MIL-M-28787/168A(SH)
AMENDMENT 3
30 July 1991
SUPERSEDING
AMENDMENT 2
23 September 1983

MILITARY SPECIFICATION

MODULES, STANDARD ELECTRONIC

MEMORY, READ ONLY, PROGRAMMABLE, DIGITAL, KEY CODE GYC

FIGURE 10 V_{OUT} (low-loaded) test circuit for table V

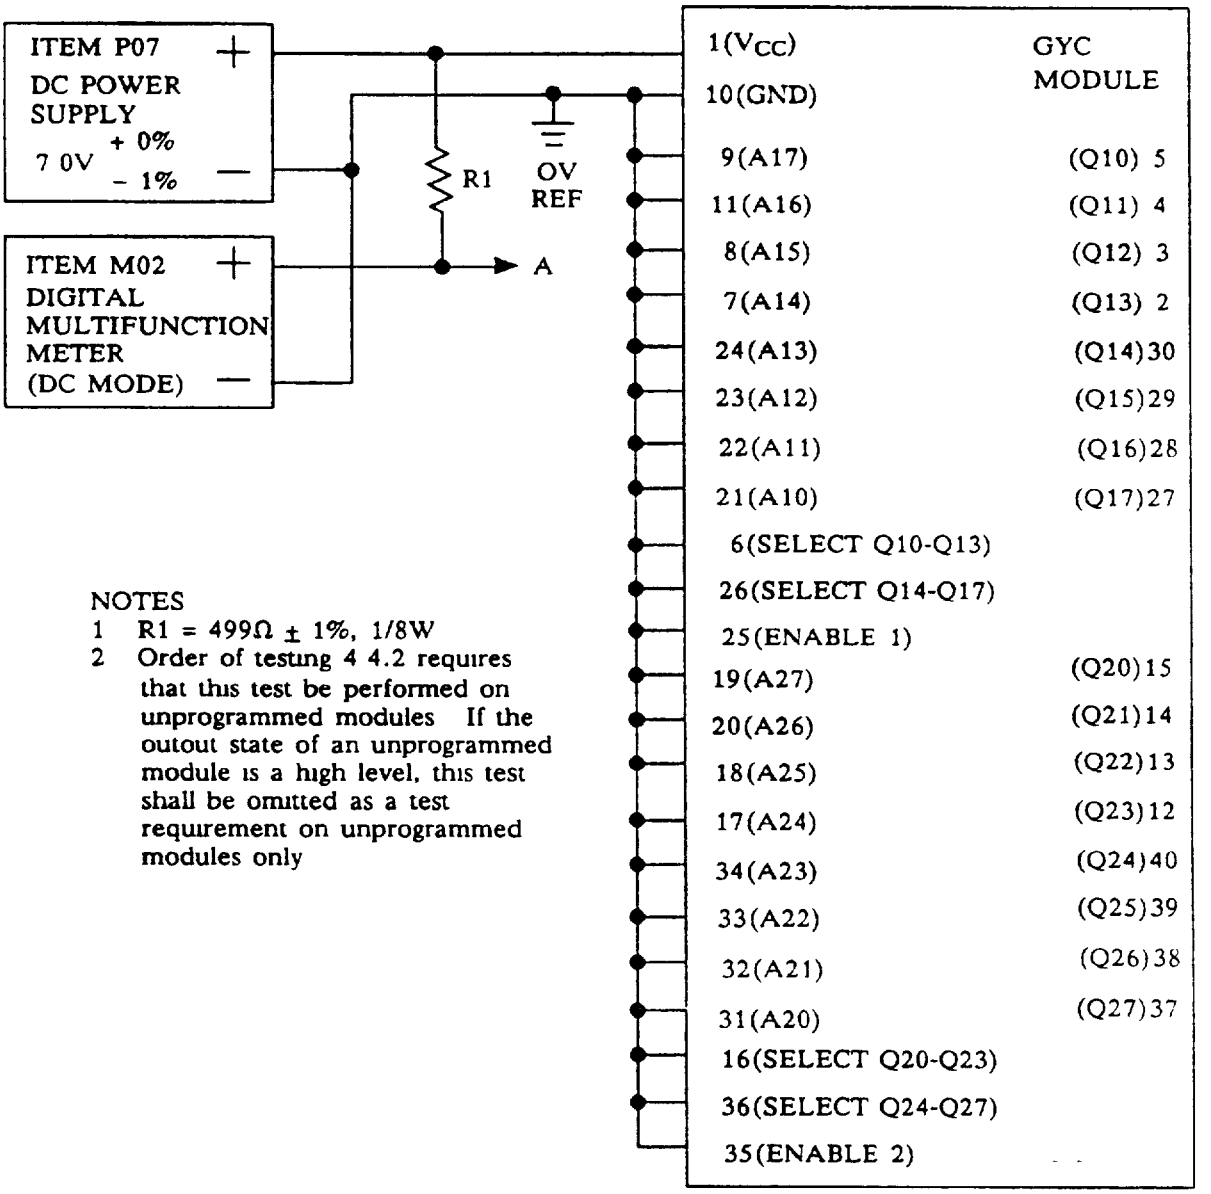
FIGURE 10 Delete and substitute new figure 10 as printed on page 4 of this amendment

NOTES
1 R1 = 499Ω ± 1%, 1/8W
2 Order of testing 4 4.2 requires that this test be performed on unprogrammed modules If the outout state of an unprogrammed module is a high level, this test shall be omitted as a test requirement on unprogrammed modules only

FIGURE 11 Input clamp diode voltage test circuit for table VI

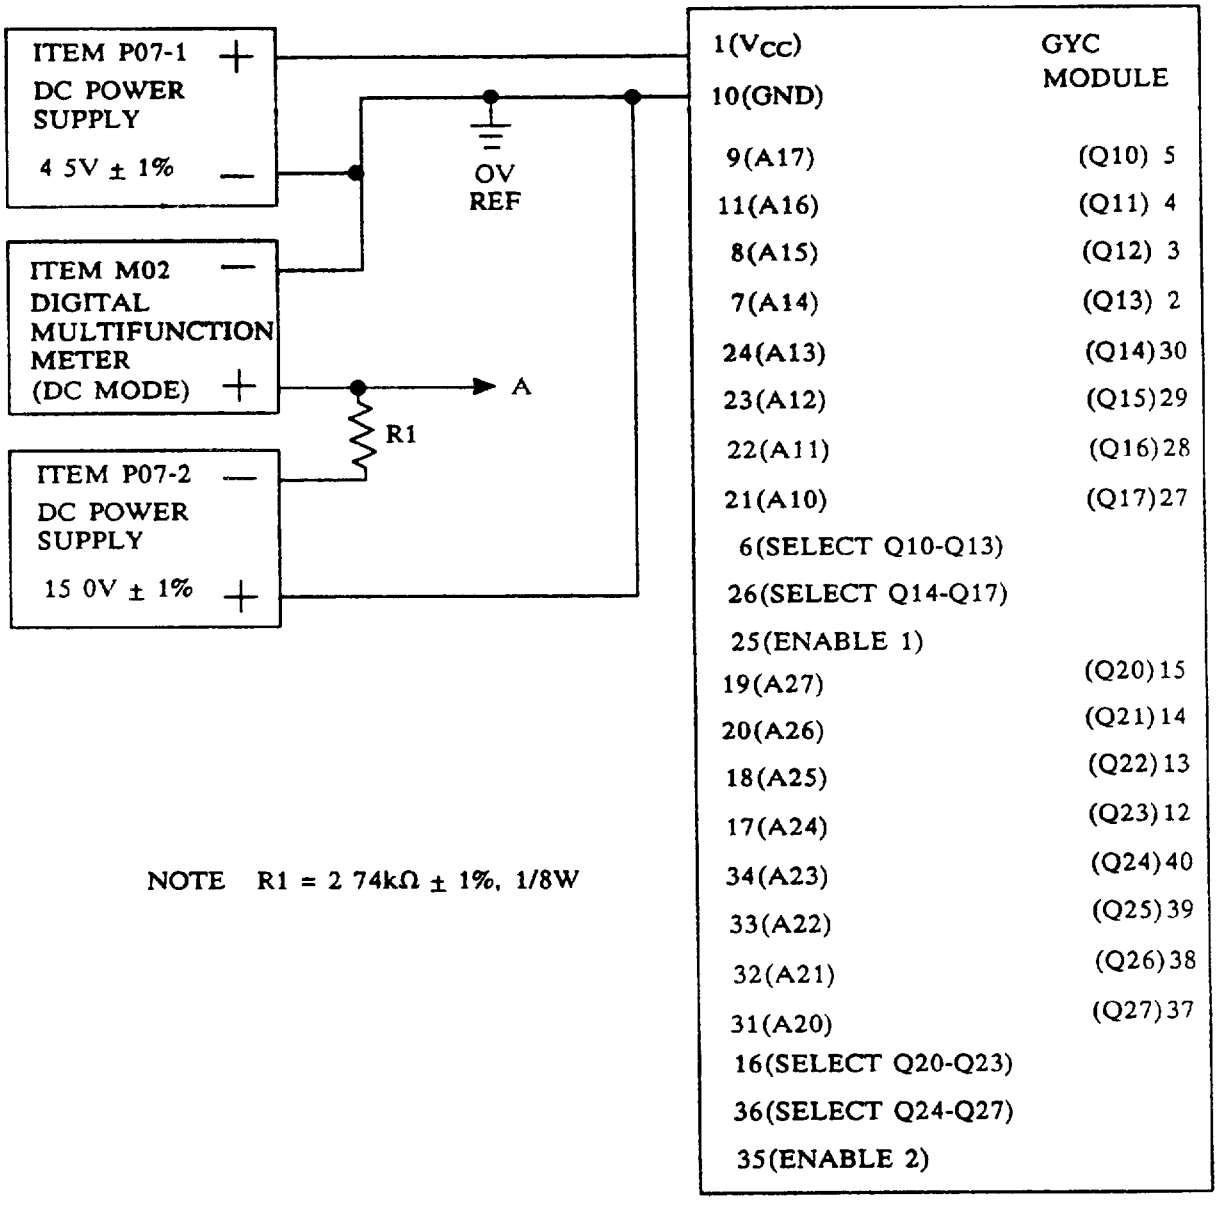
FIGURE 11 Delete and substitute new figure 11 as printed on page 5 of this amendment

NOTE R1 = 2 74kΩ ± 1%, 1/8W

FIGURE 15 Output voltage (V_0) level (unprogrammed) test circuit for table X

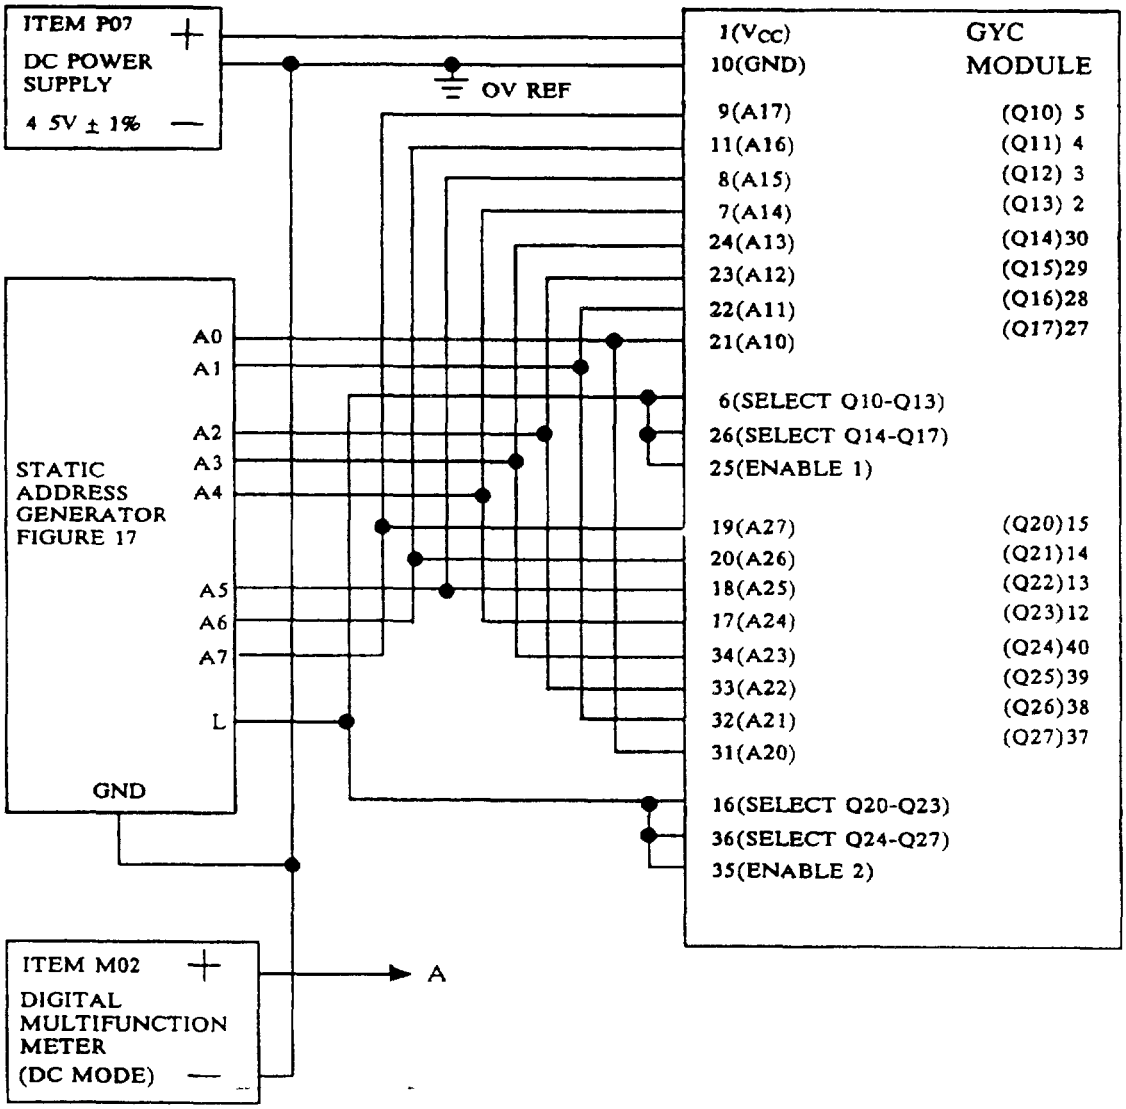
FIGURE 15 Delete and substitute new figure 15 as printed on page 6 of this amendment

1 The static address generator is used to select, in turn, each of the 256 address combinations For each address combination, each output is monitored separately at point "A" to verify that all outputs have the voltage level as specified in the user's detailed module document for an unprogrammed module If an output high level is specified, it shall be $\geq$ 2 4V, and if a low level is specified, it shall be $\leq$ 0 45V An individual module shall have either a high level or a low level for all address combinations

2 Load the output under test with a load as specified on figure 16

FIGURE 19. Functional test pattern test circuit for table XIV.

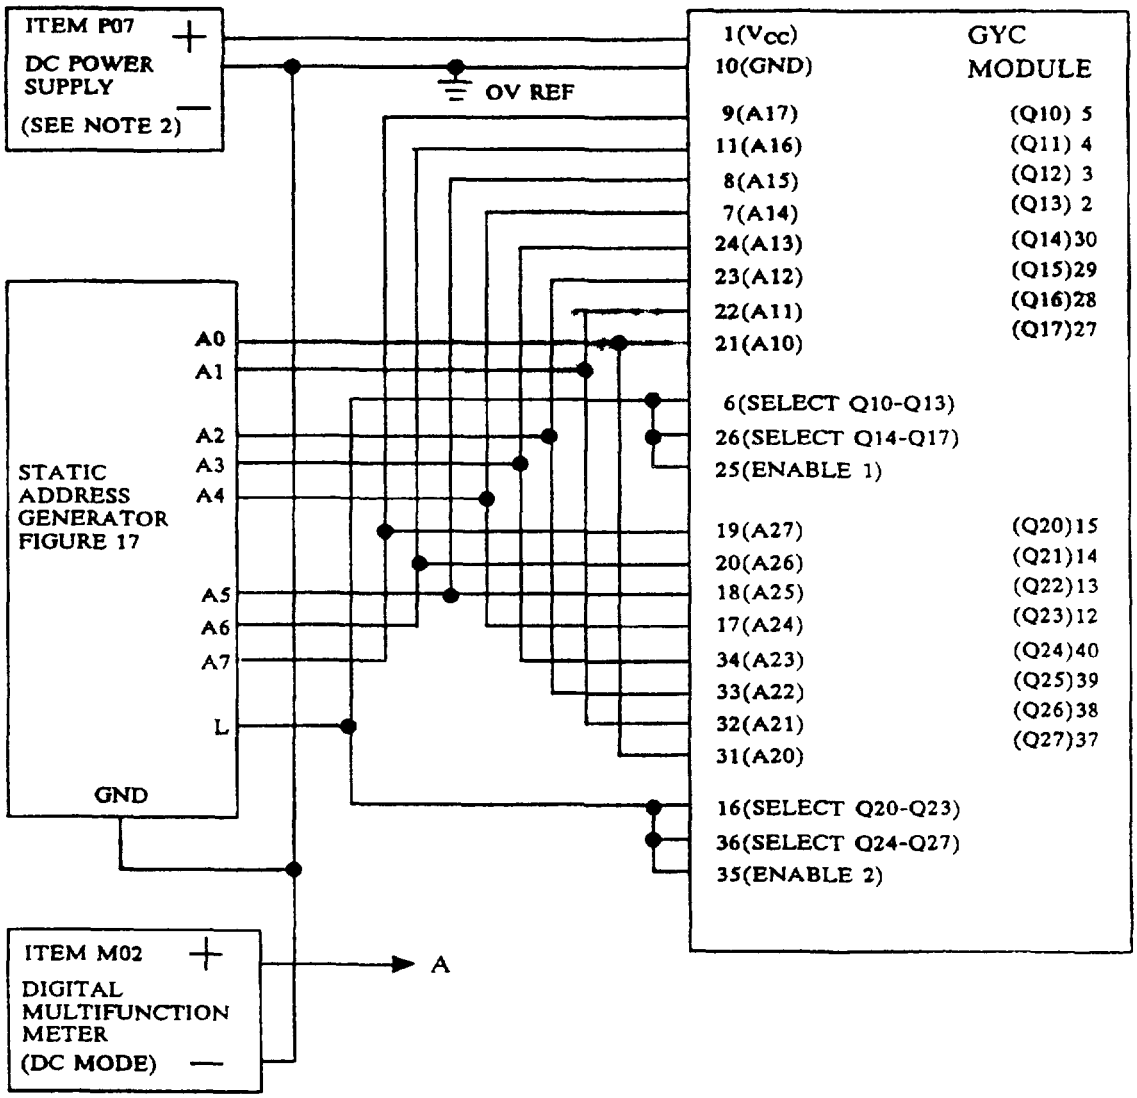
FIGURE 19 Delete and substitute new figure 19 as printed on page 7 of this amendment

1. The static address generator is used to select, in turn, each of the 256 address combinations. For each address combination, the output is monitored at point "A" to verify the test pattern in table XIII. Output high level shall be $\geq$ 2.4V and output low level shall be $\leq$ 0.45V.
2. Adjust item P07 either as specified in the user's detailed module document or, if not specified, to 4.5V $\pm$ 1%.
3. Load the output under test either with the load specified in the user's detailed module document or, if not specified, with the load as specified on figure 16.
4. The purpose of notes 2 and 3 is to allow the user to select a V_{CC} voltage and a load current which will insure the PROM fuse link has been blown.

FIGURE 20 Static output voltage (low-level and high-level) test circuit for table XV

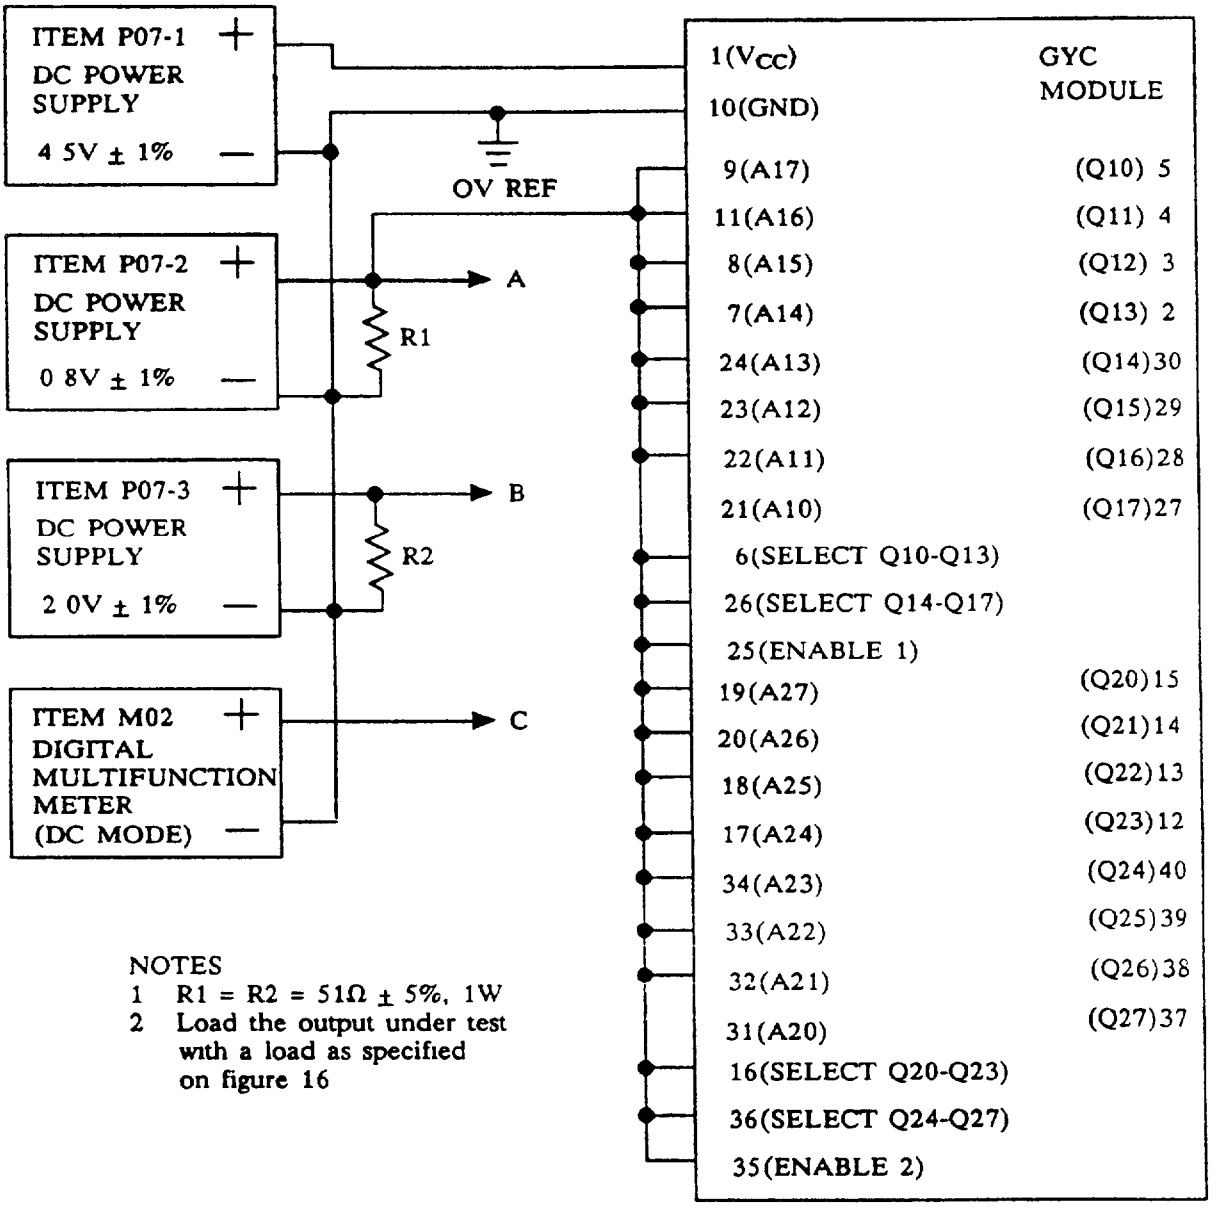
FIGURE 20 Delete and substitute new figure 20 as printed on page 8 of this amendment

NOTES
1 R1 = R2 = 51Ω ± 5%, 1W
2 Load the output under test with a load as specified on figure 16

FIGURE 25 Galloping read access pattern test circuit for table XVIII

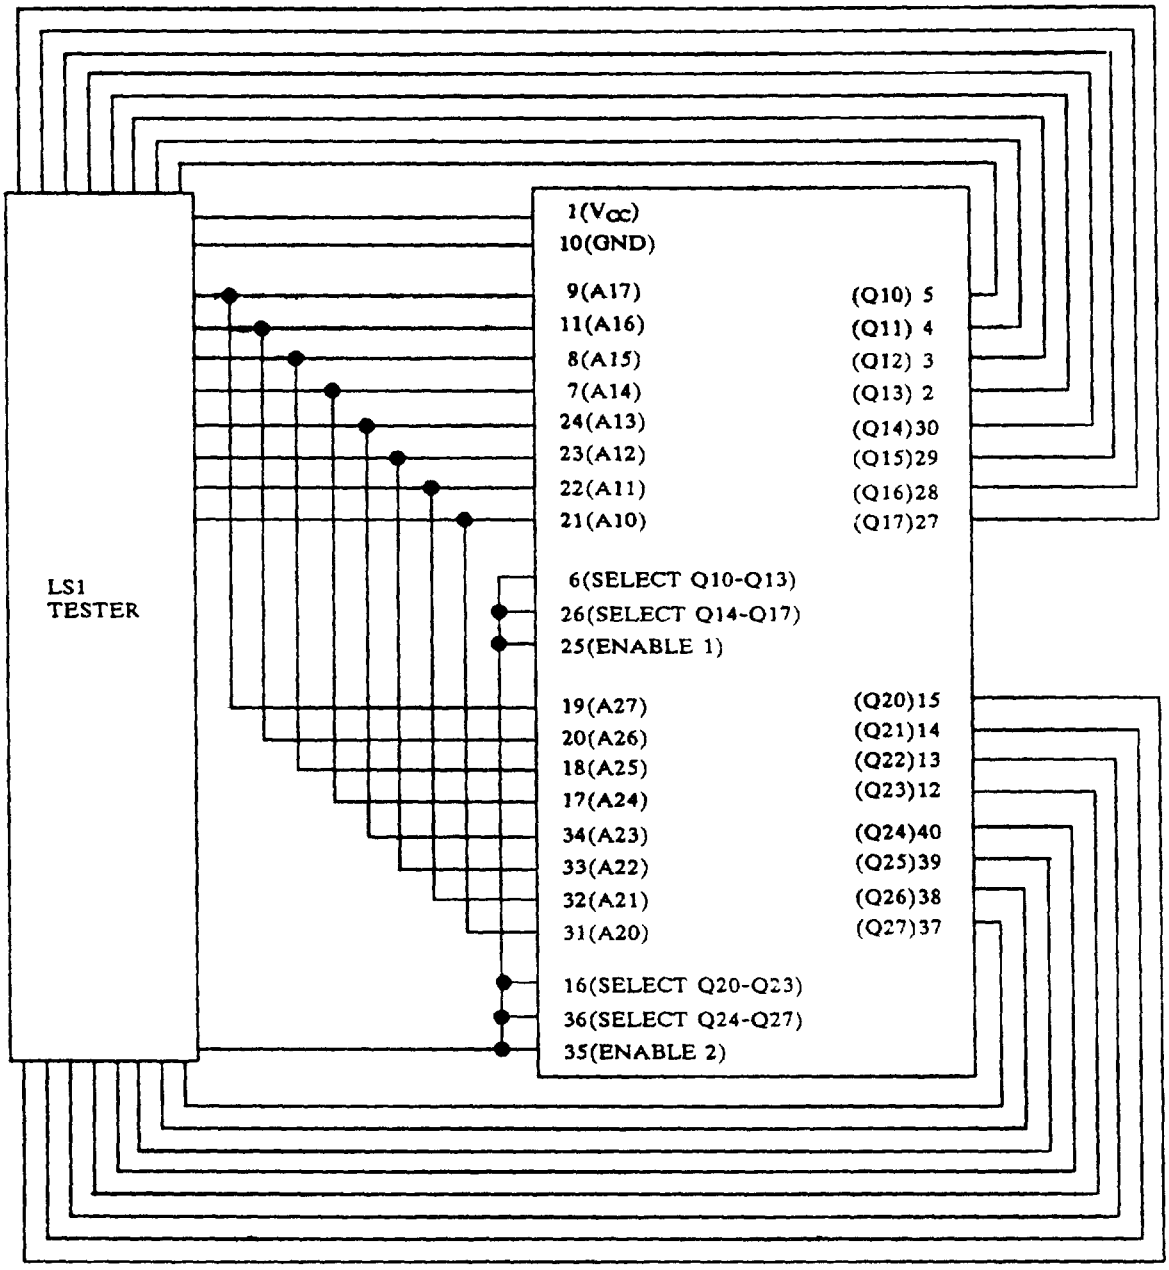
FIGURE 25 Delete and substitute new figure 25 as printed on page 9 of this amendment

NOTES
1 V_{CC} = 4 5V ± 1% for test conditions V1 and V3
2. V_{CC} = 5.5V ± 1% for test conditions V2 and V4.
3 Load output under test with a load as specified on figure 16
